Attachment J3

Submissions

Planning Submission
For: SP 67057: 23 Billyard Avenue, Elizabeth Bay

Development Application ('DA') No. 2023/0727
'Demolition of existing buildings, tree removal, excavation and construction of two new residential flat buildings, 6 to 8 storeys in height, with 22 apartments, 4 basement levels containing 27 car spaces, rooftop terraces, swimming pools and associated landscaping works including new tree plantings. The application is Integrated Development requiring the approval of Water NSW under the Water Management Act, 2000.'

Drawing title:
Sun Eye Views June 21st
11.00am-1.00pm Existing

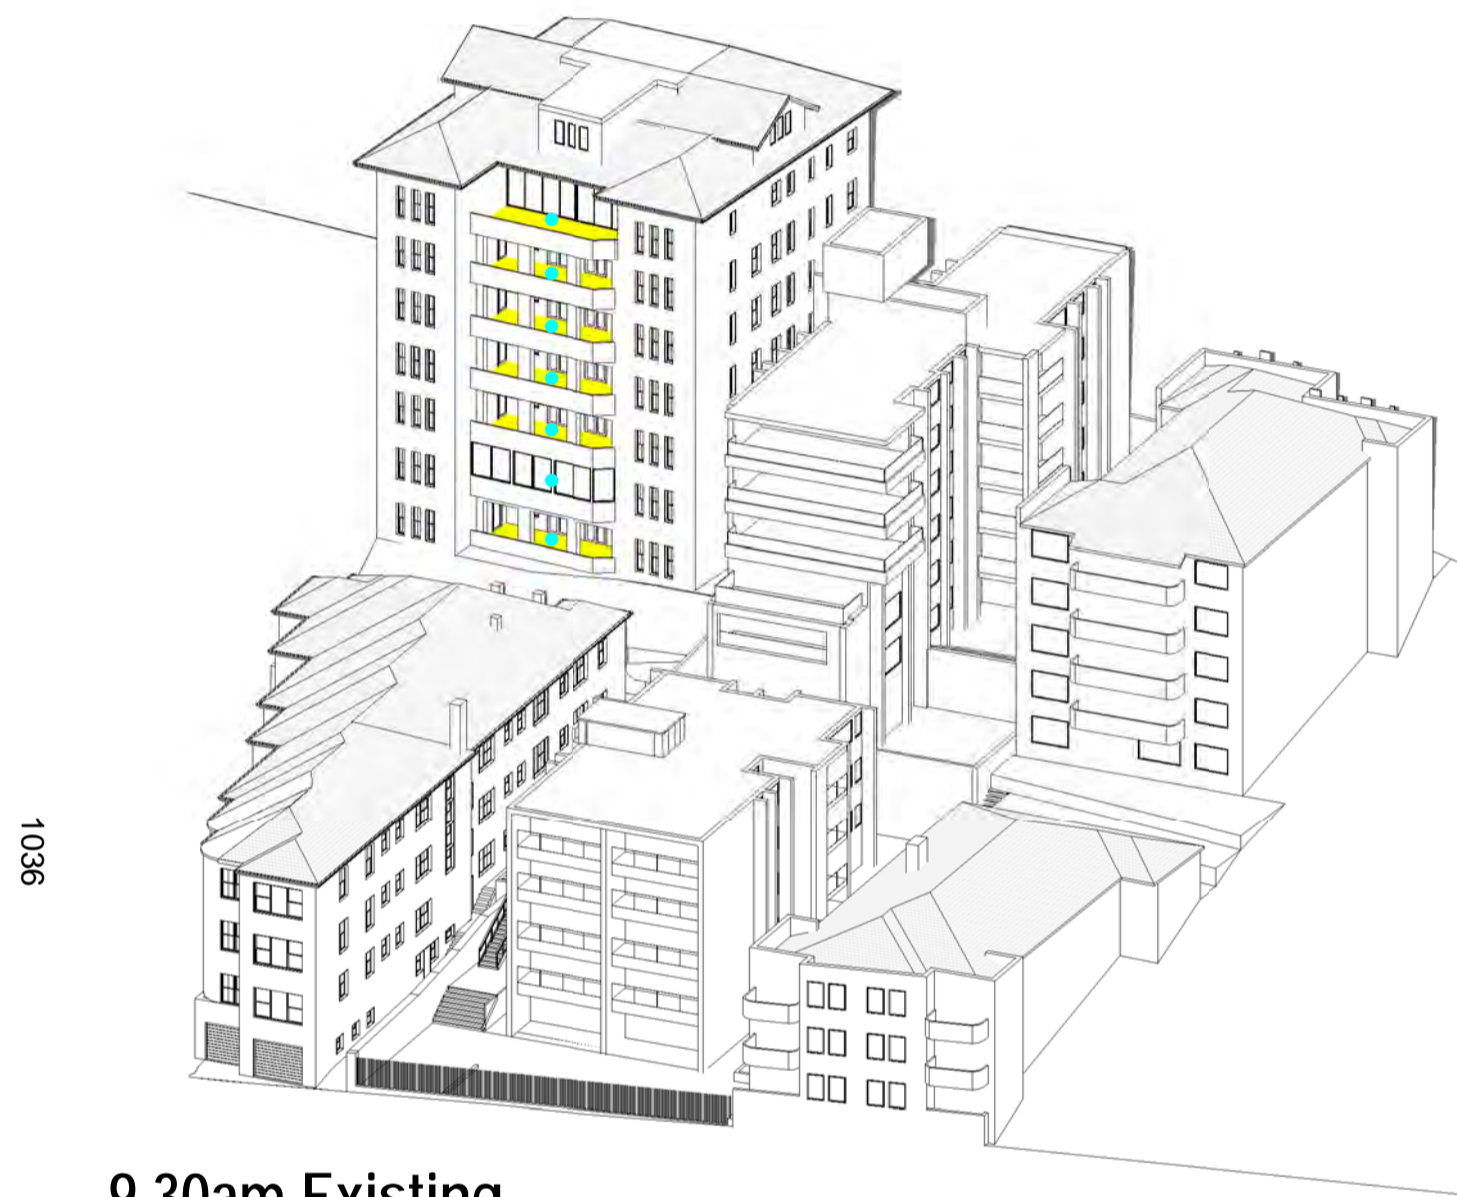
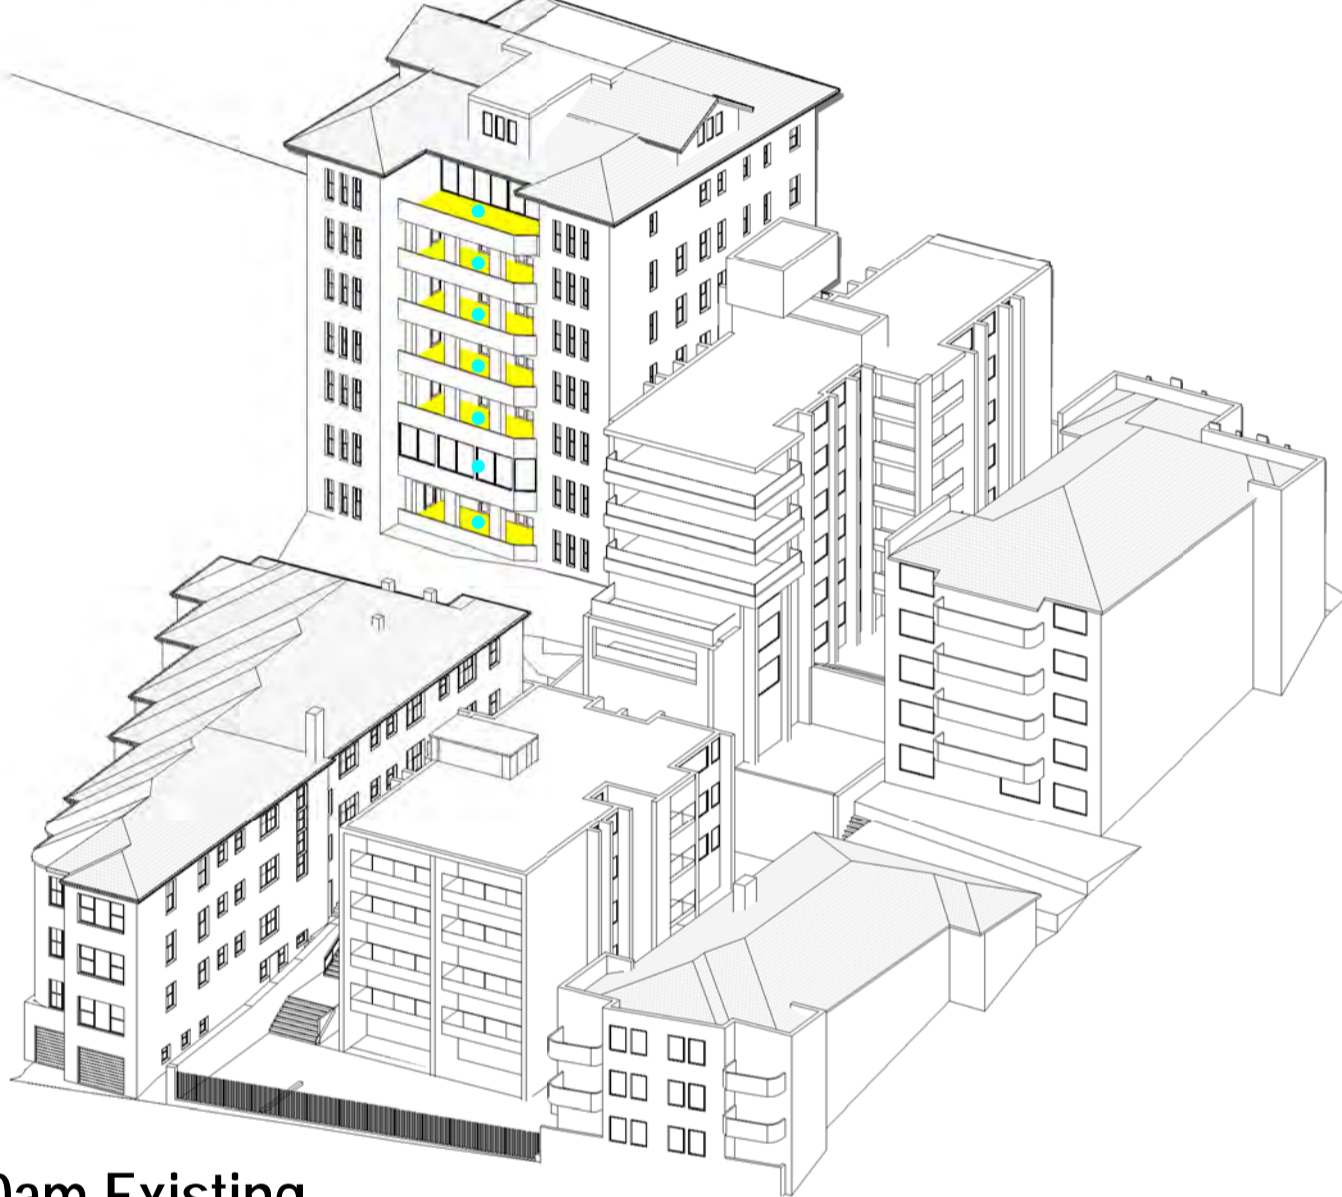
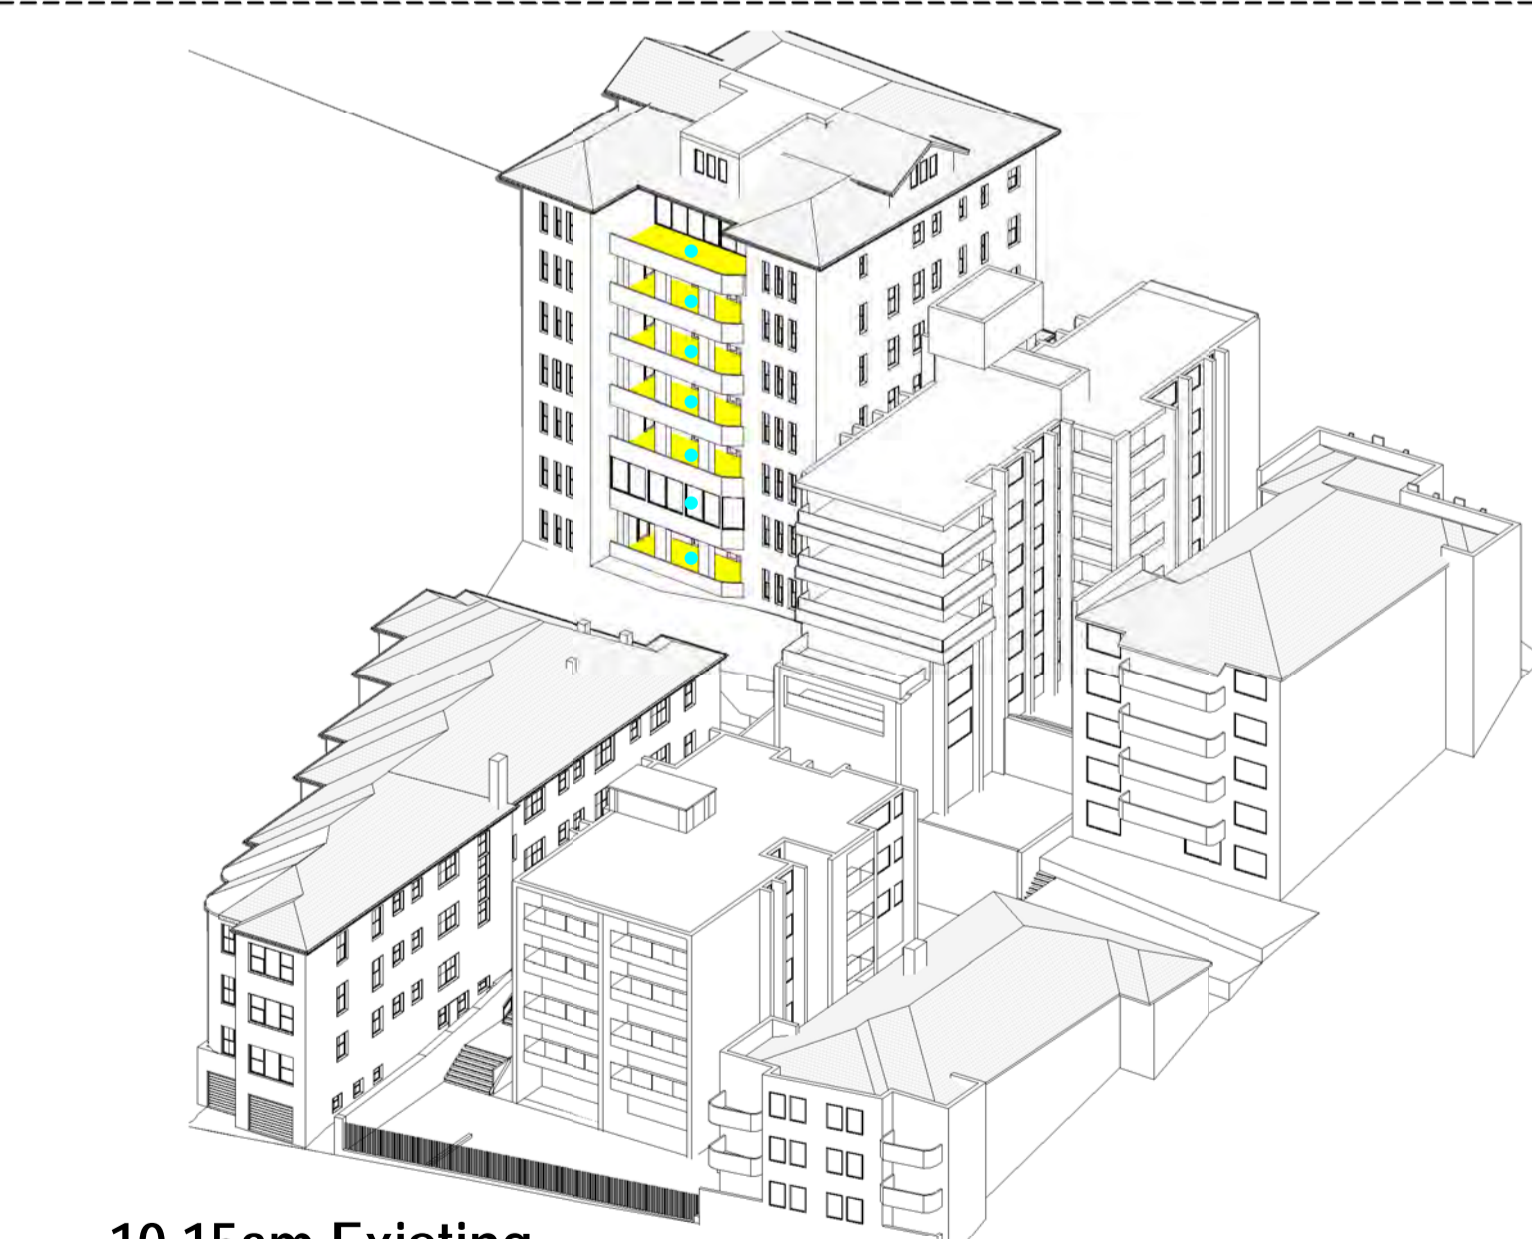
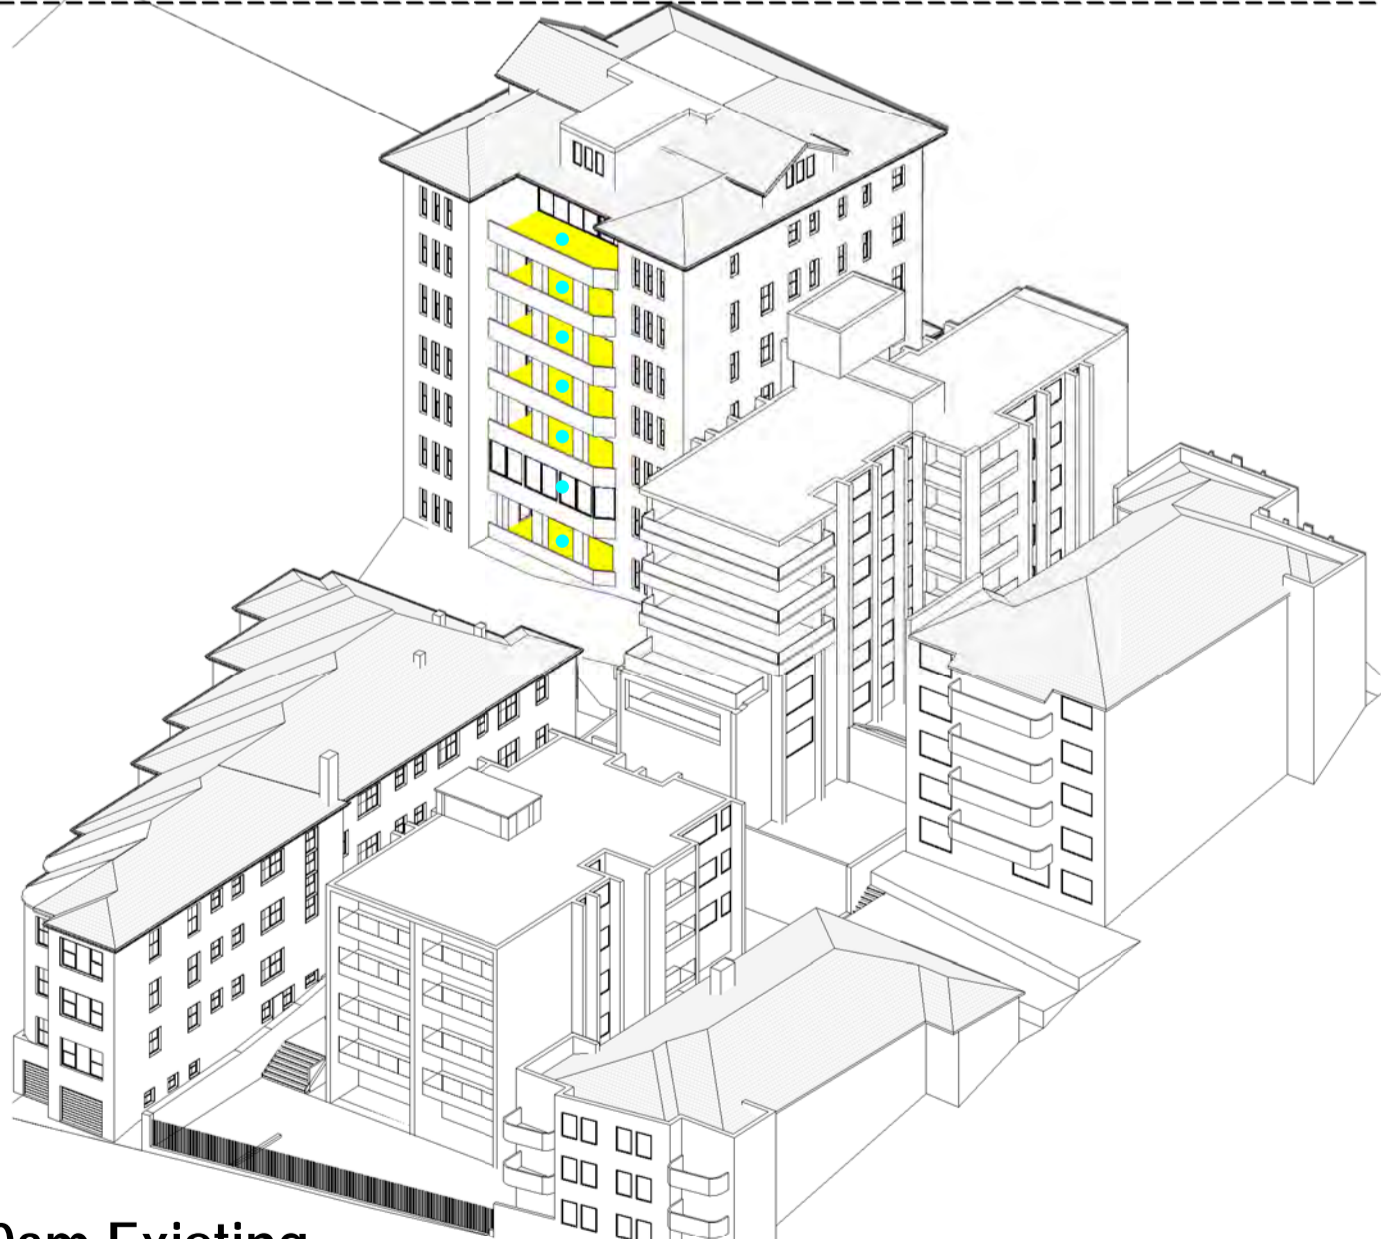
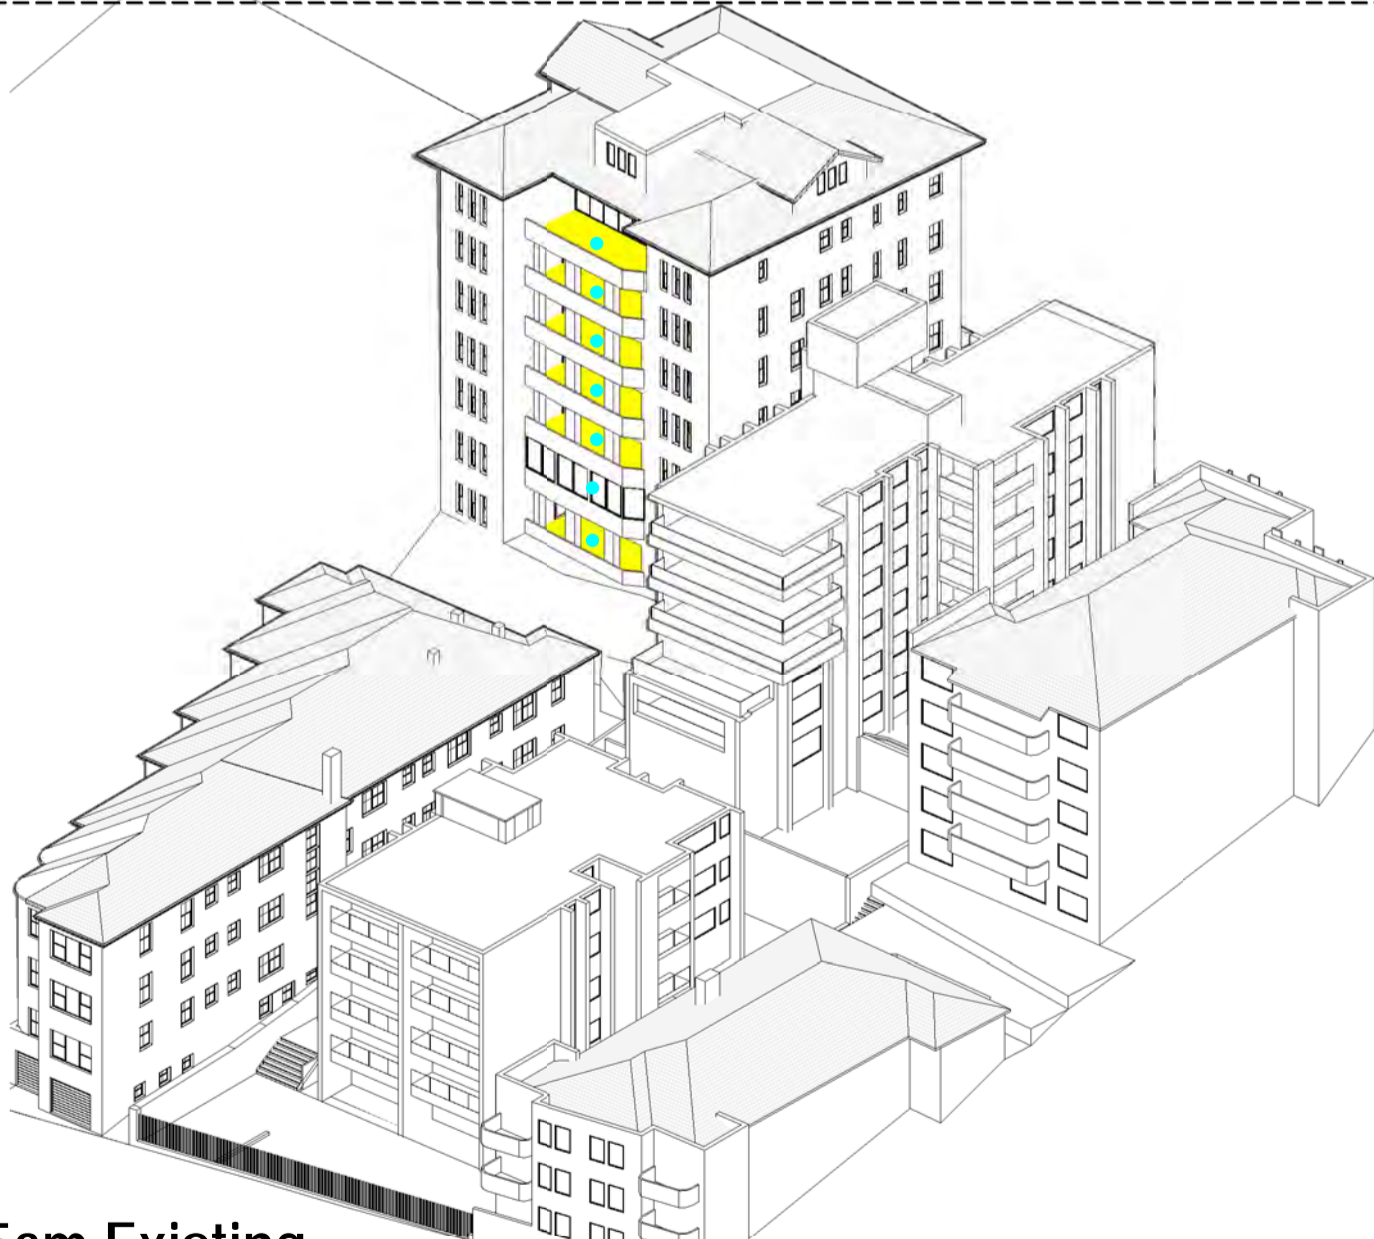
The solar diagrams show worsening of solar access to these only areas of living space (no balconies available). It is noted that staff requested 15 minute intervals and these have not been provided for 23 Billyard Avenue.

9.00AM - 3.00PM				
	EXISTING:	PROPOSED:	ACCESS LOST:	% LOST:
P.O.S.				
LG2 UNIT 1	3.25 HOURS	1.75 HOURS	- 1 HOUR	44%
LG1 UNIT 3	3.25 HOURS	1.75 HOURS	- 1 HOUR	44%
GF UNIT 5	3.25 HOURS	1.75 HOURS	- 1 HOUR	44%
1 UNIT 7	3.25 HOURS	2.25 HOURS	- 0.75 HOUR	33%
2 UNIT 9	3.25 HOURS	3.25 HOURS	0	
3 UNIT 11	3.25 HOURS	3.25 HOURS	0	
4 UNIT 12	4 HOURS	4 HOURS	0
